Security Assessment of

**Greensville/Emporia
Courthouse
Emporia, Virginia**

**Preliminary Architectural Report
GREENSVILLE COUNTY COURTHOUSE
SECURITY ENHANCEMENT PROJECT**

PRELIMINARY ARCHITECTURAL REPORT
**GREENSVILLE COUNTY COURTHOUSE
SECURITY ENHANCEMENT PROJECT**
GREENSVILLE COUNTY GOVERNMENT CENTER
EMPORIA, VIRGINIA

**GREENSVILLE
 COUNTY COURT
 HOUSE
 CCTV, ALARM, &
 ACCESS CONTROL
 LAYOUT**

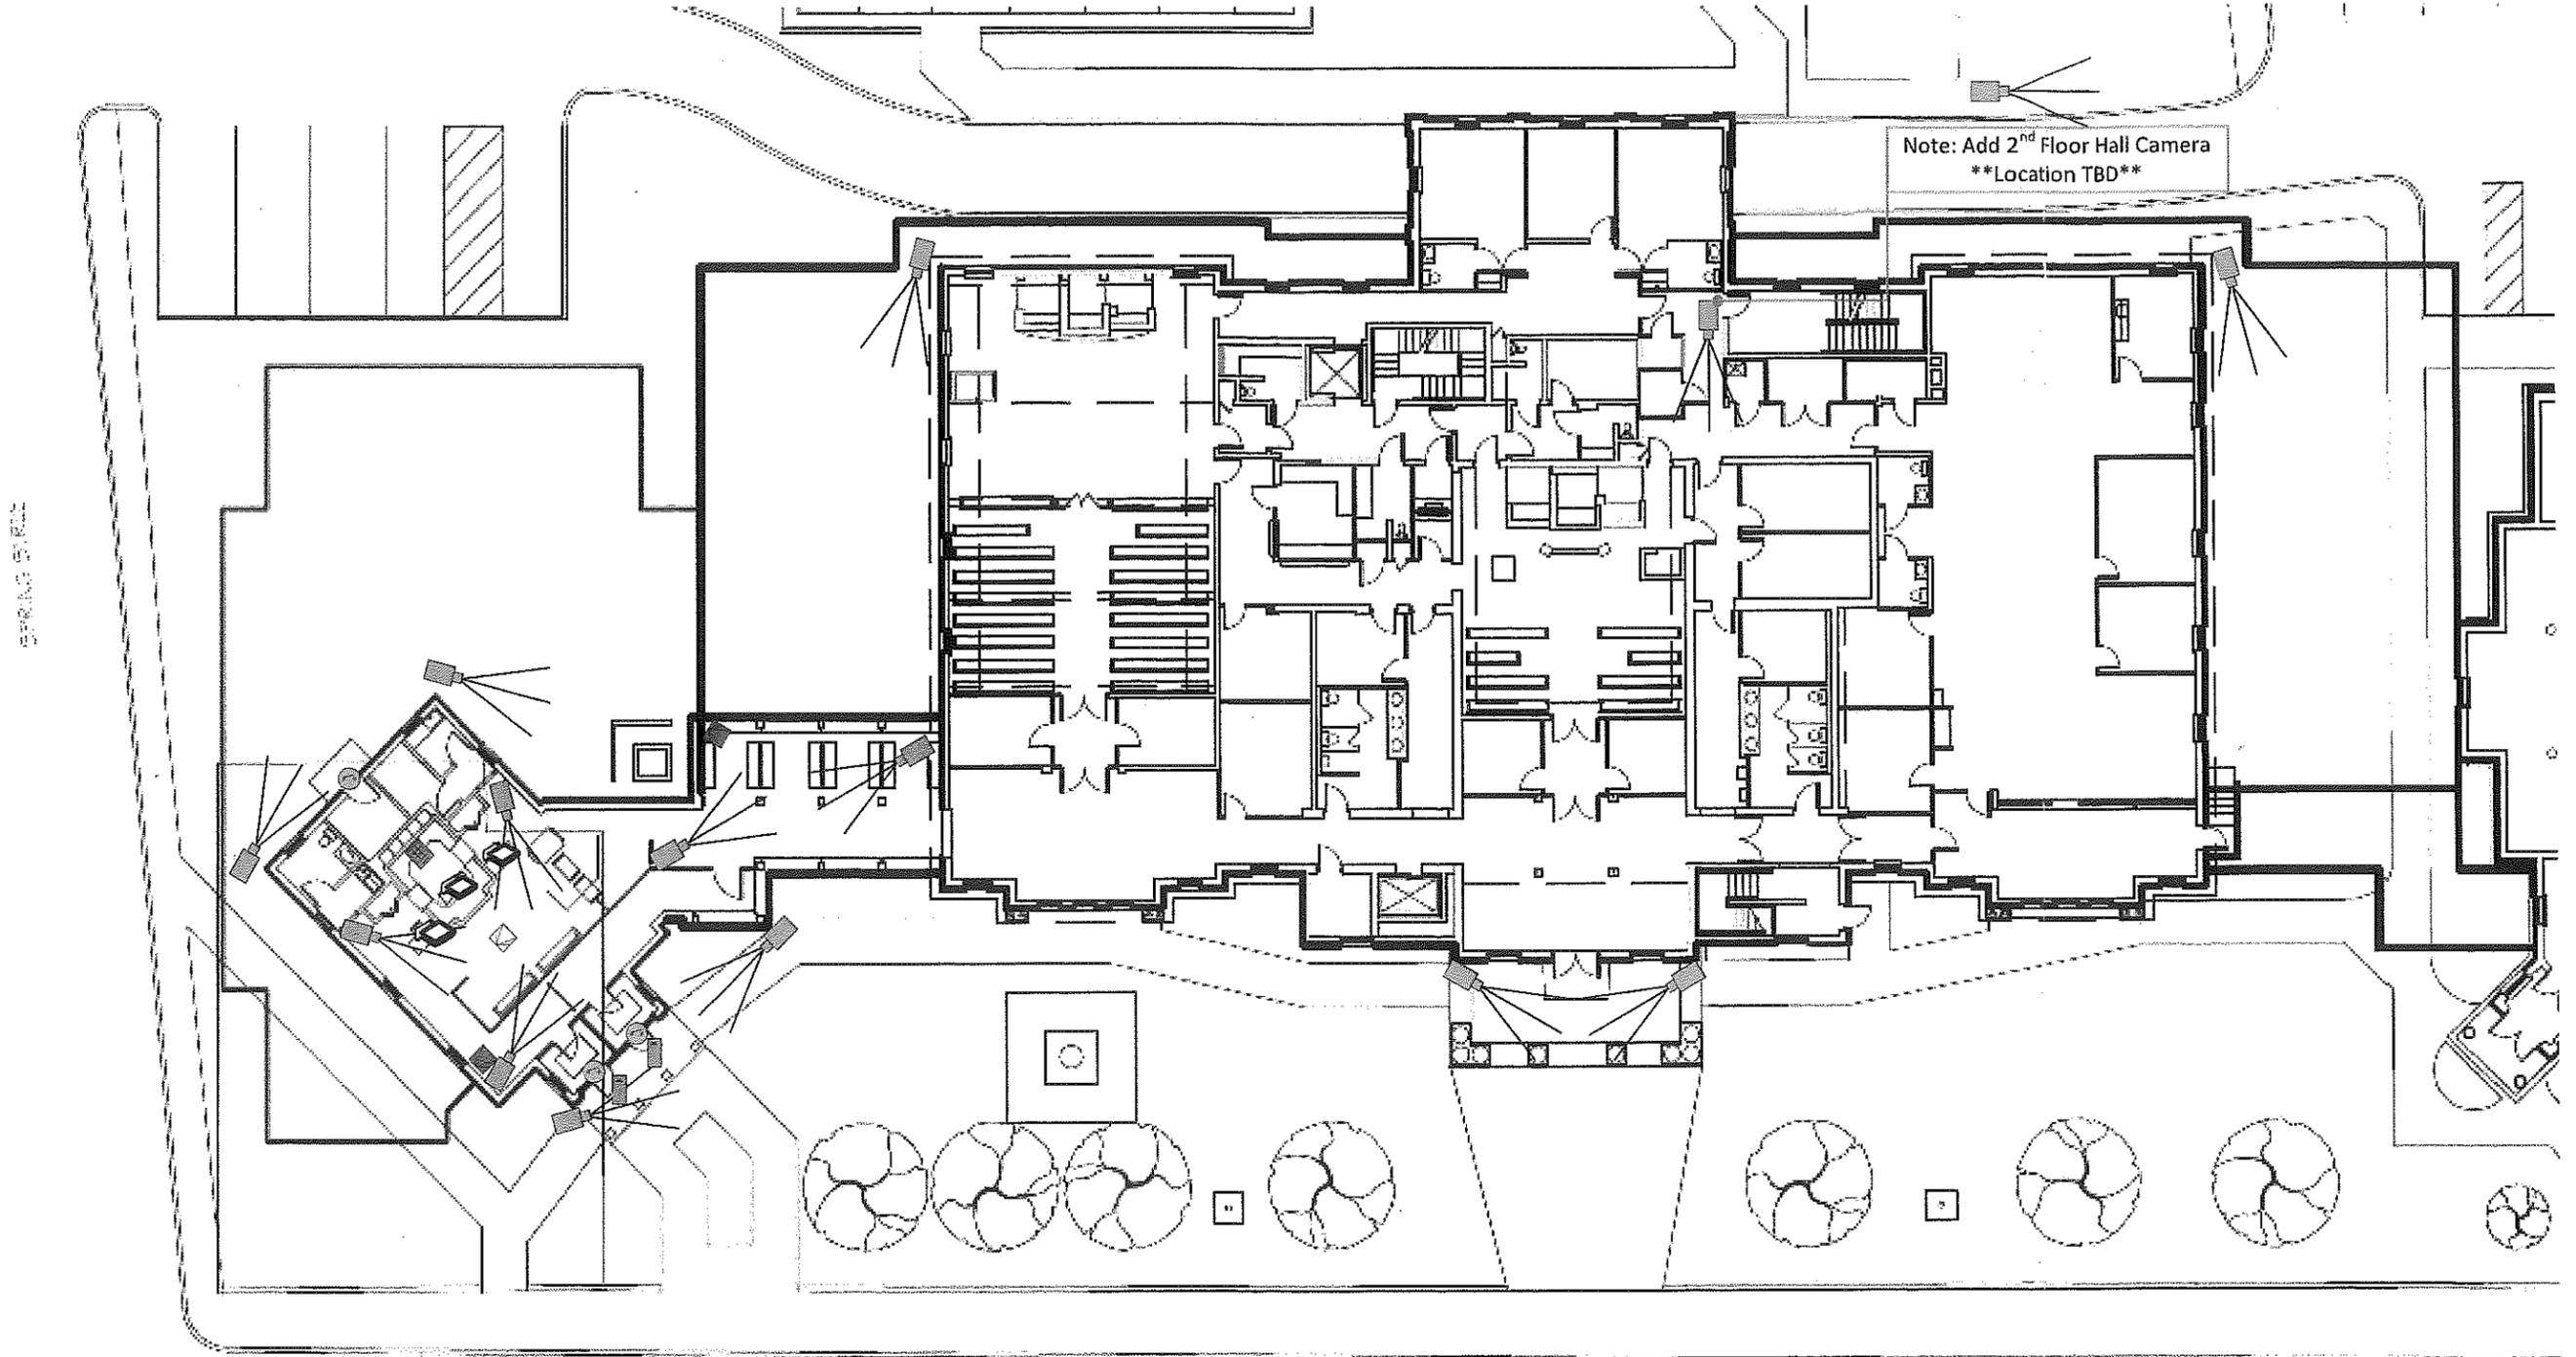
-  New Camera Coverage
-  Existing Coverage Enhancement (Replace Old, Add 2 Interior)
-  New Access Control
-  New Live Video Monitors
-  New Security Door Contacts
-  New Security Motion Detectors

Note: Add 2nd Floor Hall Camera
 Location TBD
